1997 - 1998 Corvette: Service Bulletin: Loose Lower Front Fascia Valance Panels

Number: 73-15-12A

REVISION: 07/14/98 DIVS INVL 1 7

SUBJECT: LOOSE LOWER FRONT FASCIA VALANCE PANELS (INSTALL ADDITIONAL ADDITIONAL WASHERS)

Figure 1

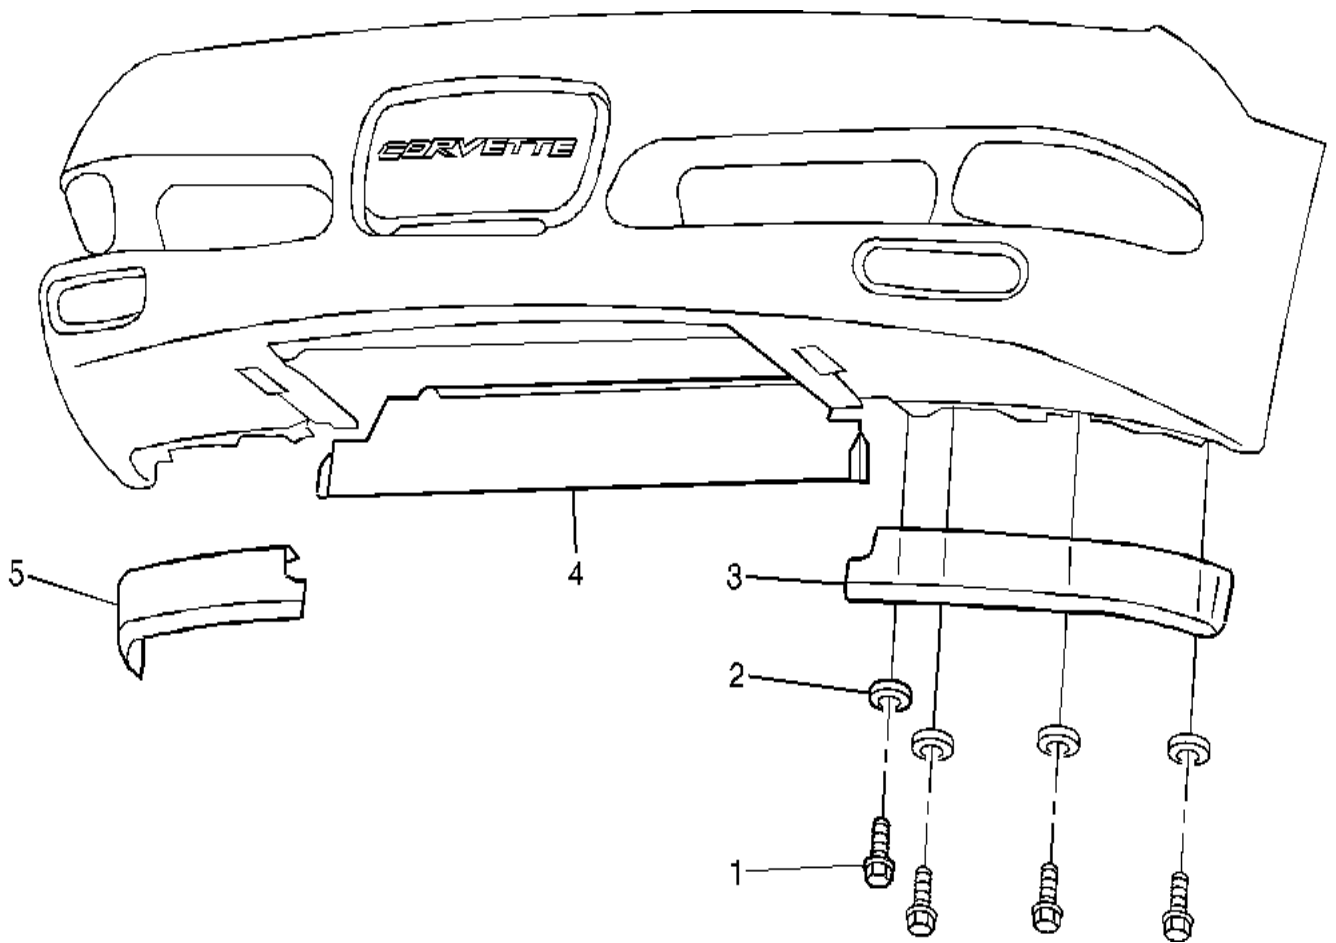
SOME OWNERS MAY COMMENT THAT THE LOWER FRONT FASCIA VALANCE PANELS APPEAR LOOSE.

THE ORIGINAL WASHERS ON THE BOLTS/SCREWS THAT ATTACH THE LOWER VALANCE PANELS TO THE FRONT FASCIA MAY HAVE WORKED THEIR WAY THROUGH THE HOLES IN THE VALANCE PANELS.

ADD ONE ADDITIONAL LARGER FLAT WASHER, P/N 11500365, 25 MM O.D. BY 6.3 MM I.D. BY 2.5 MM THICK (1 IN. O.D. BY 1/4 IN. I.D. BY 3/32 IN. THICK) TO EACH OF THE EIGHT BOLTS/SCREWS (FOUR PER VALANCE PANEL) THAT ATTACH BOTH LOWER VALANCE PANELS TO THE FRONT FASCIA (SEE FIGURE 1). TIGHTEN BOLTS TO 7 N.M (62 LB IN).
